Project Name:AT&T LTE Upgrade

Project: *AT&T Cell Tower: Adding and Removing Antennas*
Address: *1501 S Potomac St*
Occupancy Group: *IBC U*
Construction Type: *IBC TYPE VB*
RSN: *643347*
Permit: *12-583367-LT*

City of Aurora Building Division
Reviewed for Code Compliance
Approved as Noted: *J Van Essen*
Date: *Feb 22, 2012*
2009 INTERNATIONAL CODES & 2011 NEC

ELECTRICAL PANEL SCHEDULE AND ONE-LINE DIAGRAM

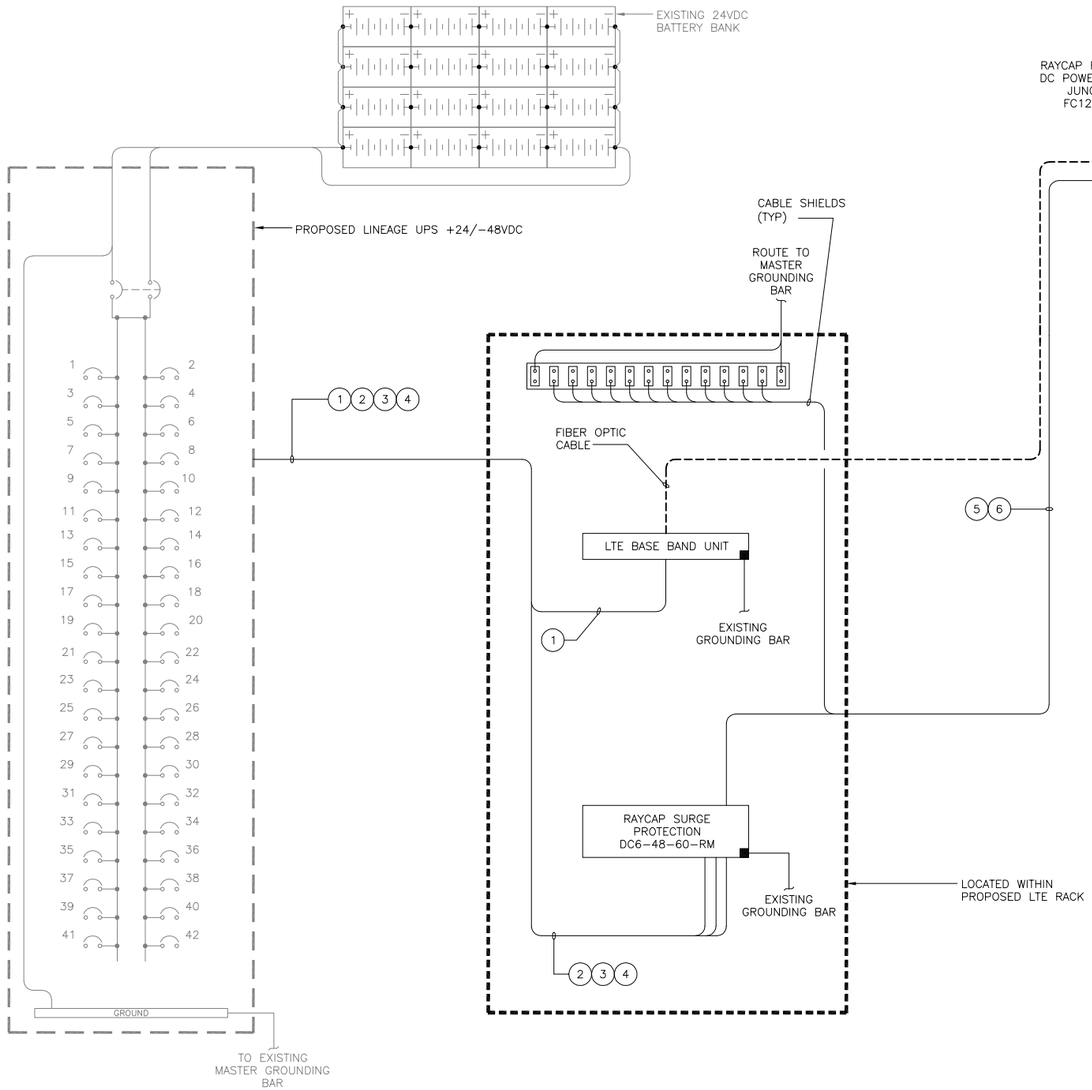
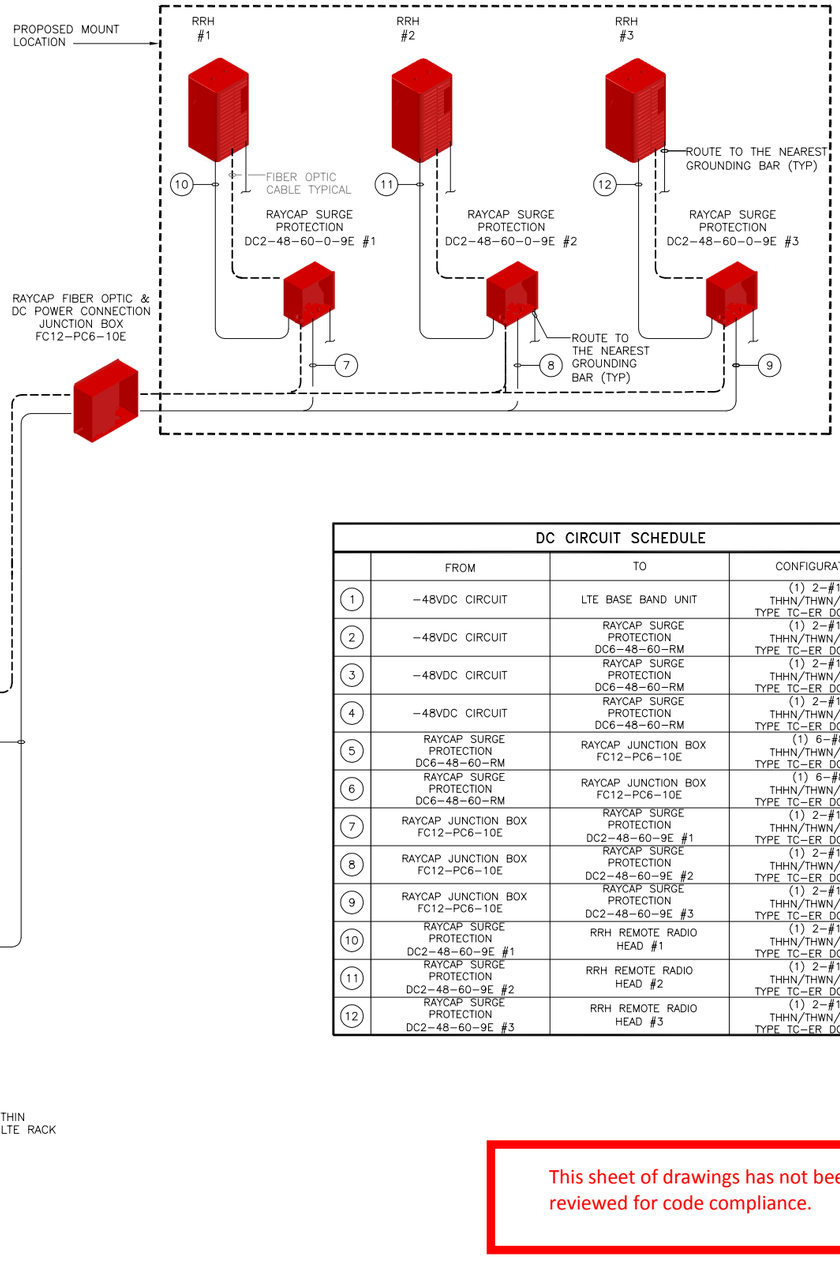
The rating of all series rated panels shall be marked on the panels. Provide manufacturers information and cut sheets onsite and available during field inspections **per 2011 NEC 240.86 (B)**

Provide a grounded electrode system bonded to the service equipment enclosure, grounded conductors, and grounded electrode conductors **per 2011 NEC 250.50 and 250.104**
